The Commission has issued the enclosed Amendment No. 53 to Facility Operating License No. NPF-12 for the Virgil C. Summer Nuclear Station, Unit No. 1. The amendment consists of changes to the Technical Specifications in response to your application dated February 7, 1986.

The amendment revises Technical Specification 3/4.4.9, "Pressure/Temperature Limits-Reactor Coolant System," and its bases, and changes the withdrawal order and schedule for the reactor vessel specimen capsules, as well as the plant heatup and cooldown rates. The amendment is effective as of its date of issuance and shall be implemented within 30 days of issuance.

Amendment No. 53
License No. NPF-12

SAFETY EVALUATION BY THE OFFICE OF NUCLEAR REACTOR REGULATION
RELATED TO AMENDMENT NO. 53 TO FACILITY OPERATING LICENSE NO. NPF-12

Figure 3-4-2 Reactor Coolant System Pressure - Temperature Limits Versus 100°F/Hour and 50°F/Hour Heatup Rate - Criticality Limit and Inservice Leak Test Limit

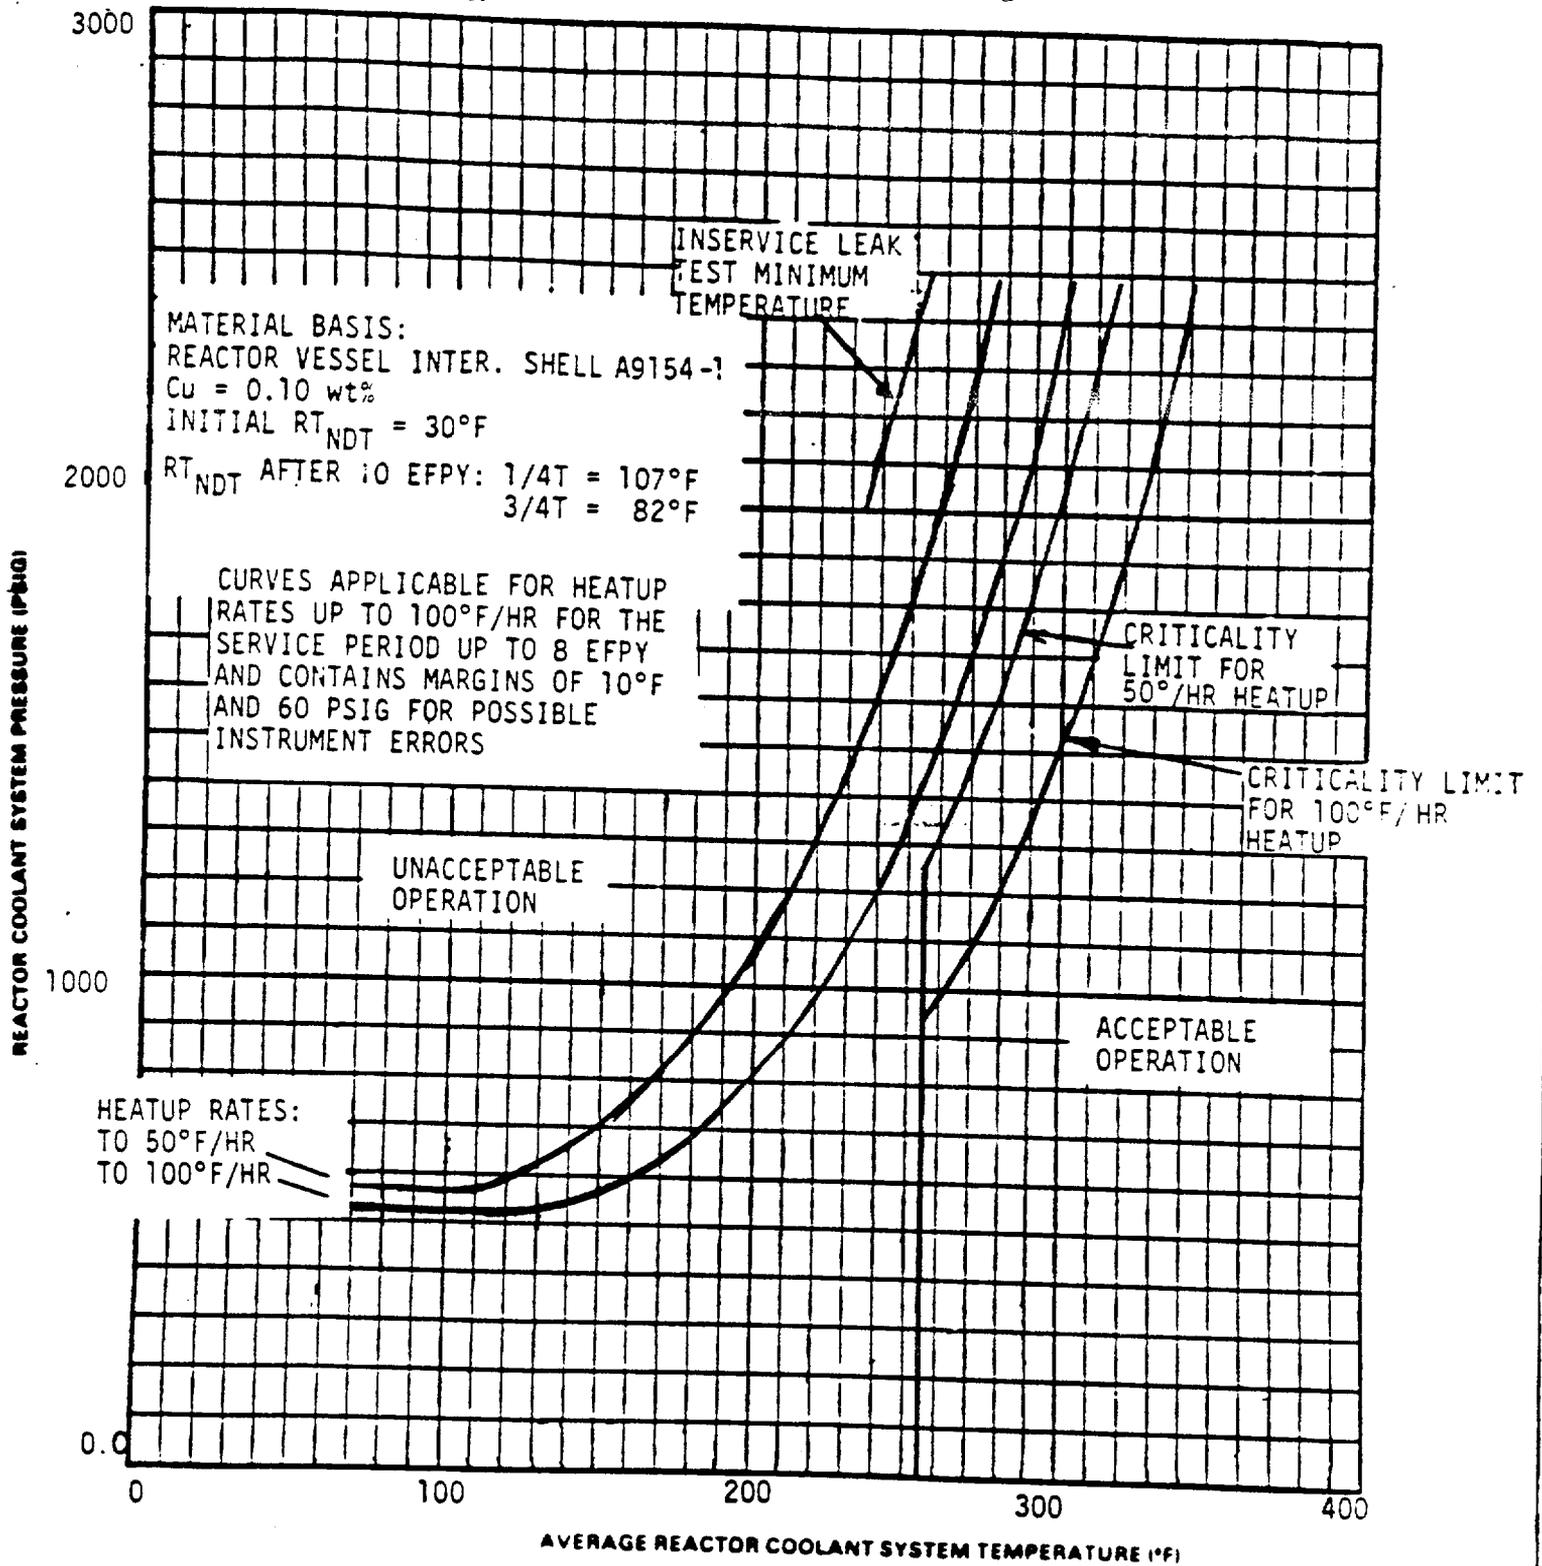
3.4.9.1 The Reactor Coolant System (except the pressurizer) temperature and pressure shall be limited in accordance with the limit lines shown on Figures 3.4-2 and 3.4-3 during heatup, cooldown, criticality, and inservice leak and hydrostatic testing with:

- a. A maximum heatup of 100°F in any one hour period,
- b. A maximum cooldown of 100°F in any one hour period, and
- c. A maximum temperature change of less than or equal to 10°F in any one hour period during inservice hydrostatic and leak testing operations above the heatup and cooldown limit curves.

Allowable combinations of temperature and pressure for specific temperature change rates are below and to the right of the limit lines shown on the heatup and cooldown curves. The reactor must not be made critical until pressure-temperature combinations are to the right of the criticality limit line shown in Figure 3.4-2. This is in addition to other criteria which must be met before the reactor is made critical.

The leak test limit curve shown in Figure 3.4-2 represents minimum temperature requirements at the leak test pressure specified by applicable codes. The leak test limit curve was determined by methods of References 2 and 4.

The NRC staff has used the method of calculating pressure-temperature limits in USNRC Standard Review Plan 5.3.2, NUREG-0800, Rev. 1, July 1981, to evaluate the proposed pressure-temperature limits. The amount of neutron irradiation damage was calculated using design basis calculated neutron fluences and the Regulatory Guide 1.99, Rev. 1, prediction curves. The NRC staff concludes that the proposed pressure-temperature limits meet the safety margins of Appendix G, 10 CFR 50 for 8 EFY and therefore may be incorporated into the plant's Technical Specifications.

Figure 3.4-3
 Reactor Coolant System Pressure - Temperature Limits
 Versus Cooldown Rates

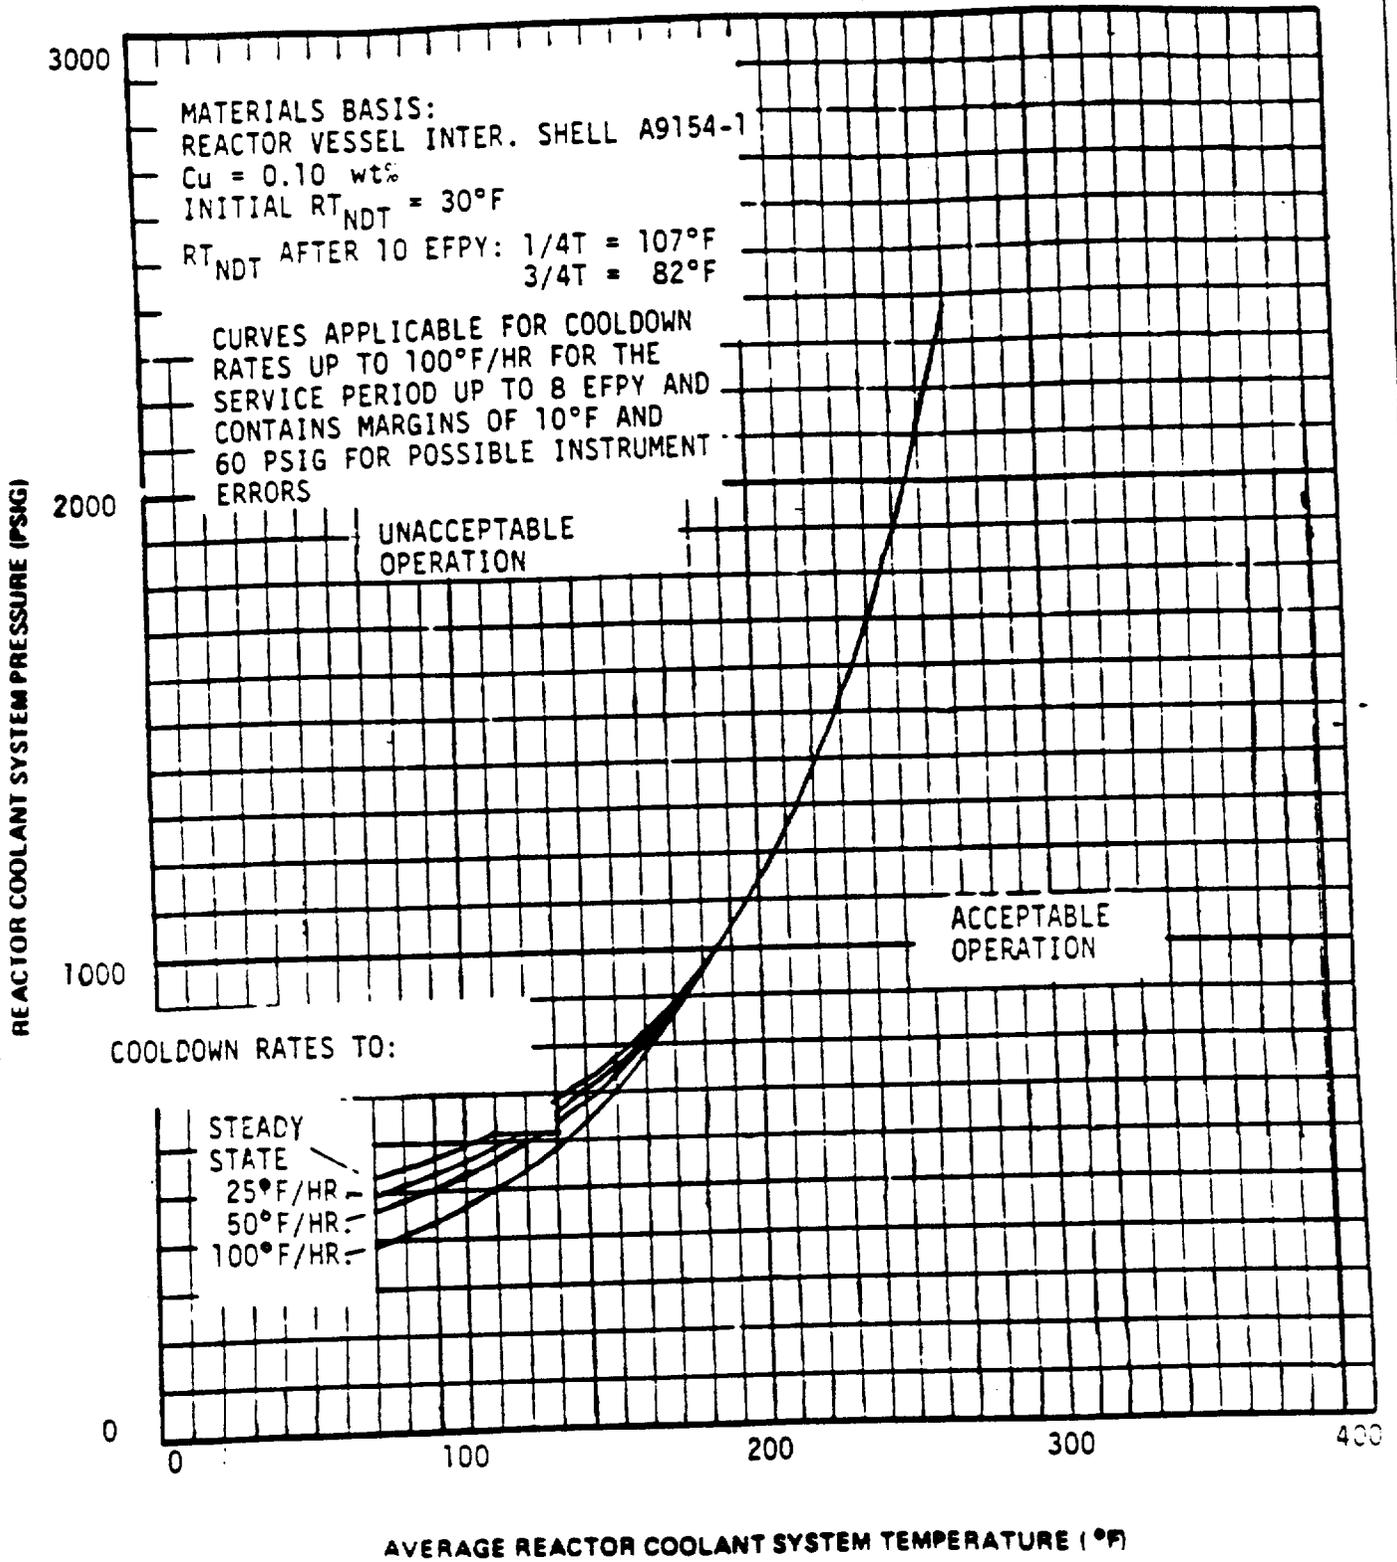
Transition temperature shifts occurring in the pressure vessel materials due to radiation exposure have been obtained directly from the reactor pressure vessel surveillance program. Charpy test specimens from Capsule U indicate that both the surveillance weld metal and core region intermediate shell plate code no. A9154-1 exhibited shifts in RT_{NDT} of $30^{\circ}F$ at a fluence of 6.39×10^{18} n/cm². This shift is well within the appropriate design curve (Figure B 3/4.4.2) prediction. Therefore, the heatup and cooldown curves in Figures 3.4-2 and 3.4-3 are based on the trend curve in Figure B 3/4.4.2 and these curves are applicable up to 8 effective full power years (EFPY). The heatup curve in Figure 3.4-2 is not impacted by the new 10 CFR 50 rule. However, the cooldown curve in Figure 3.4-3 is impacted by this 10 CFR 50 rule.
